## Campus Plan Amendment: Related to the area southeast of the Jaqua Triangle Design Area

Proposed *Campus Plan* Amendments: Maximum Allowed Densities, Open Space Framework, and Design Area Special Conditions

May 28, 2021 DRAFT (Incorporates all changes discussed by the CPC. Changes made since the April 30<sup>th</sup>, 2021 CPC meeting are highlighted in yellow).

**Proposed Pathway Amendments (orange)**

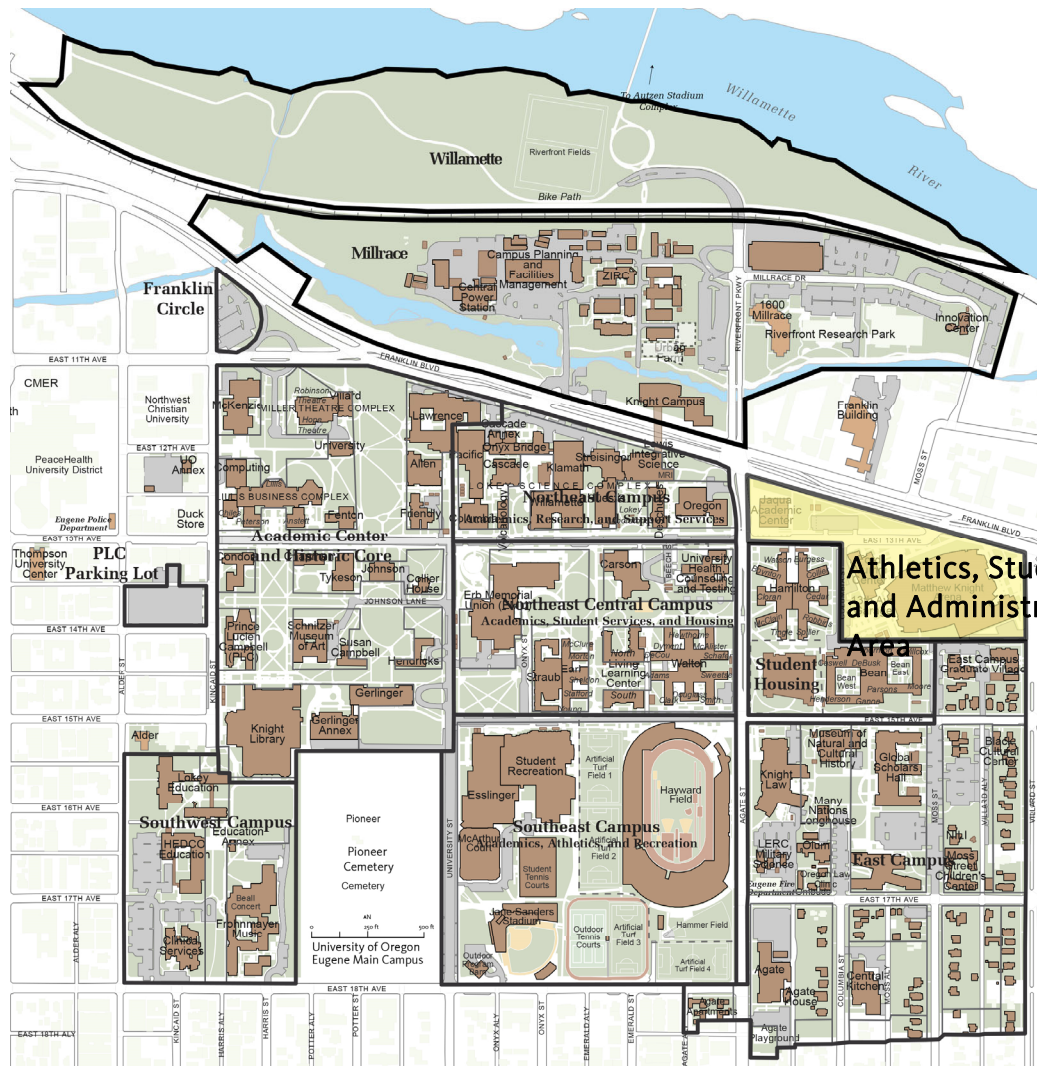
- B. Amend the *Campus Plan Map 4: Pathways* (page 41) to incorporate the new pathways as shown in orange on the map below.
